FINAL
ENVIRONMENTAL IMPACT STATEMENT

URS Corporation
1421 Chapala Street
Santa Barbara, California 93101

This is a programmatic environmental impact statement (EIS) for adoption of the proposed Mineral Resource Management Plan (MRMP) for Vandenberg Air Force Base (VAFB).

Figure 6.5-5
COMPLIANCE ACTIVITIES IN MEDIUM CONSTRAINT AREAS

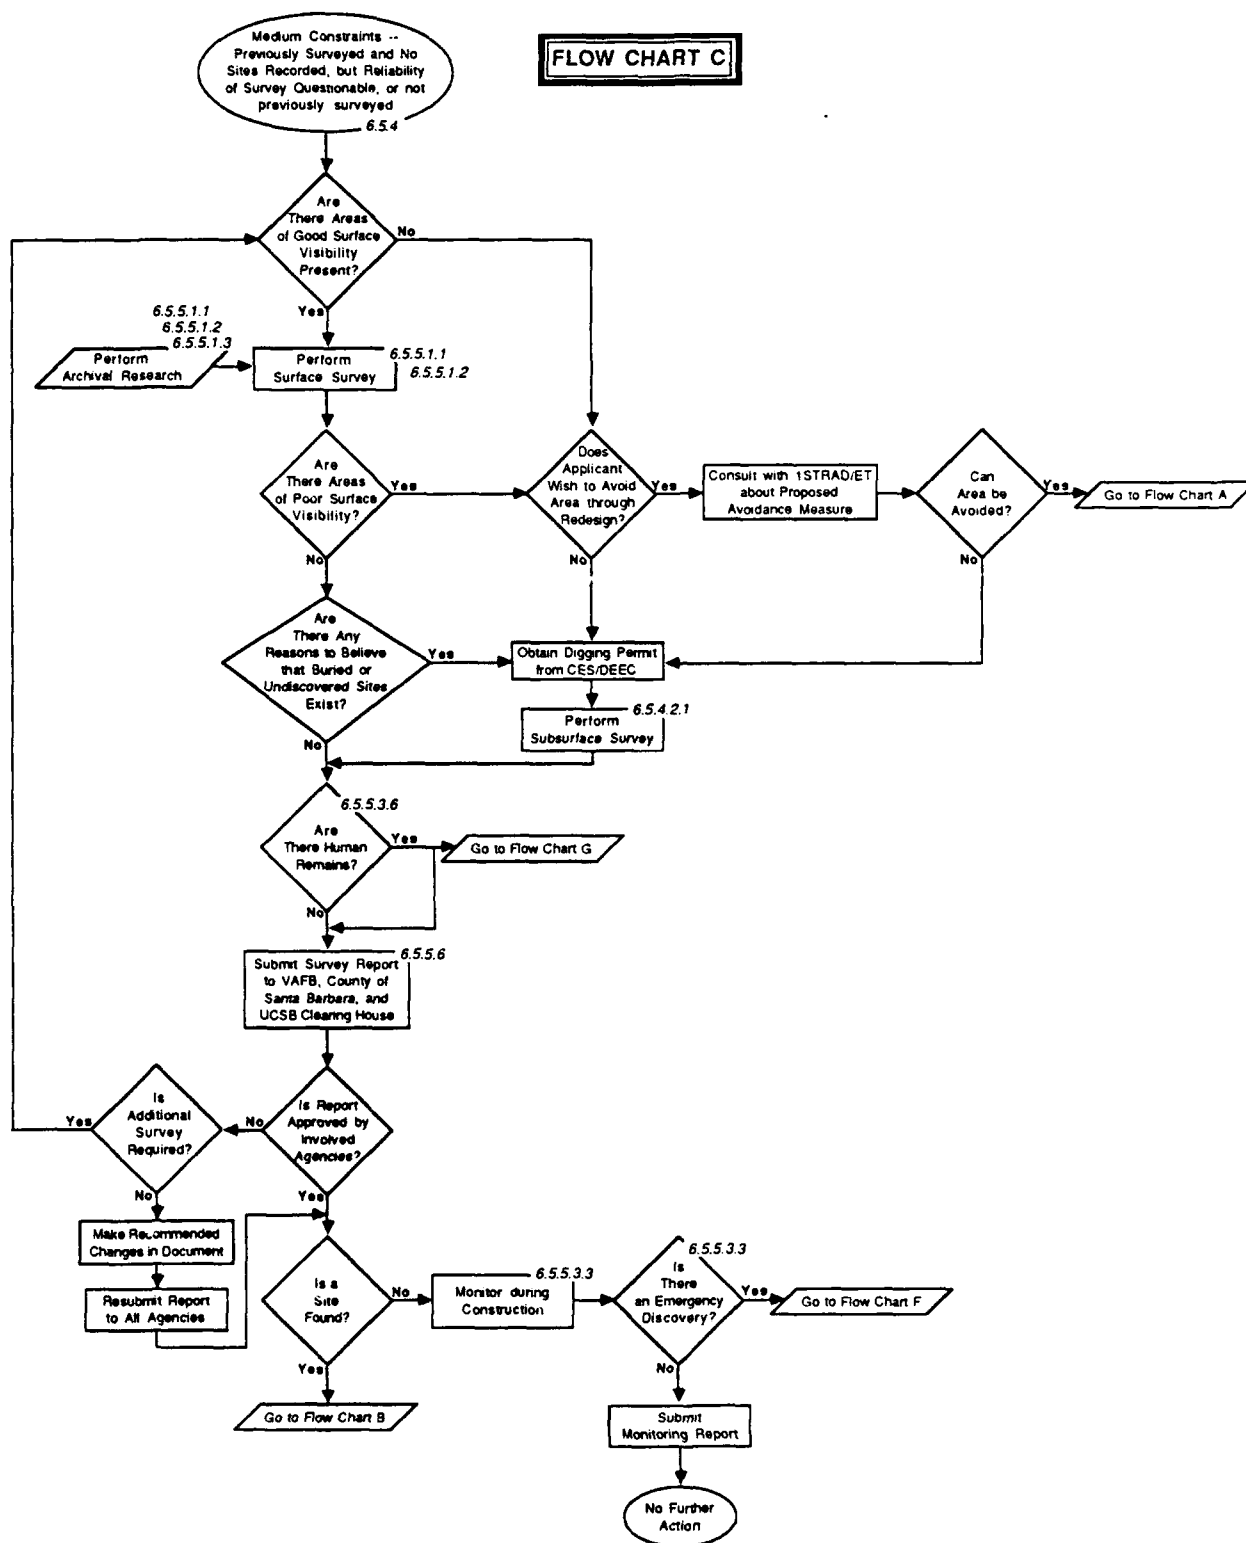
Page 6.5-24, Figure 6.5-5 is replaced with the attached.

Union-41 The MRMP policies and guidelines are in complete agreement with this comment, and flow charts B, C, and D (Figures 6.5-23, 6.5-24, and 6.5-25) have been modified to show more clearly that project redesign may be implemented prior to the performance of subsurface survey. Please see the MRMP errata for section 6.5, Cultural Resources.

Figure 6.5-6

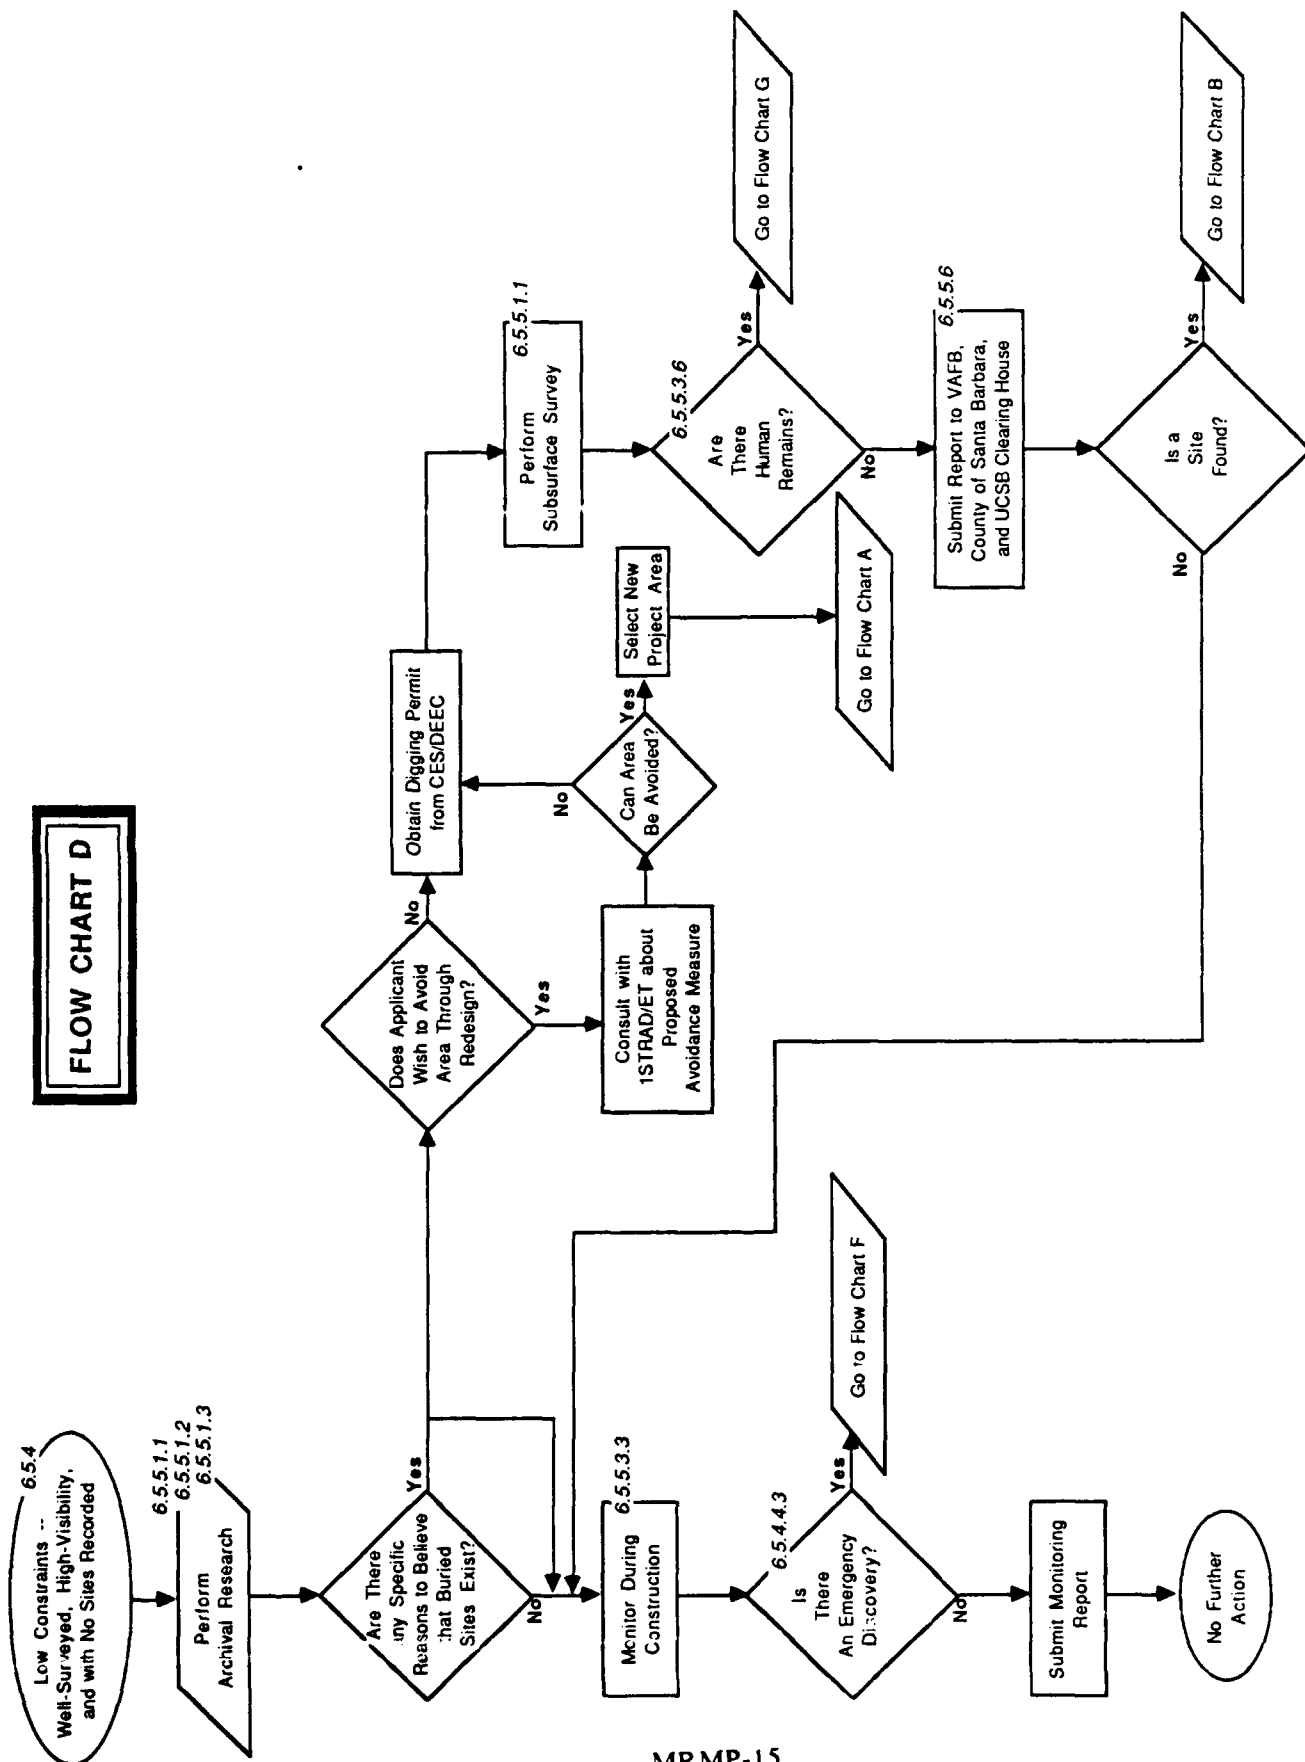
Page 6.5-25, Figure 6.5-6 is replaced with the attached.

Figure 6.9-7
STEAM GENERATOR

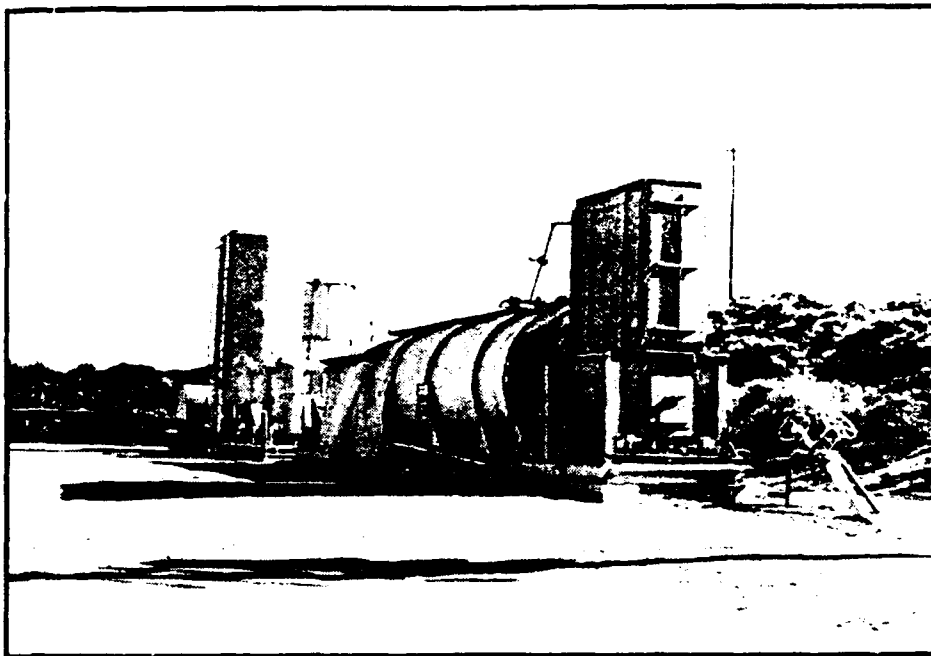
Paragraph 3 states that "electrical equipment...and installation of pipelines...would also effect air quality". Considering the subject, there Union-47 appears to be a typo and "visual" should be in place of "air" in the sentence. Figure 6.9-7 is incorrectly titled "H₂S Scrubber". This photograph depicts a steam generator.

Figure 6.9-7 on page 6.9-10 has been retitled "Steam Generator" as shown on the attached figure.

- Union-46 Refer to the response to comment Union-20.
- Union-47 Your comment is addressed in the MRMP errata. The word "air" in the sentence has been changed to "visual," and Figure 6.9-7 has been correctly titled, as shown in the MRMP errata.
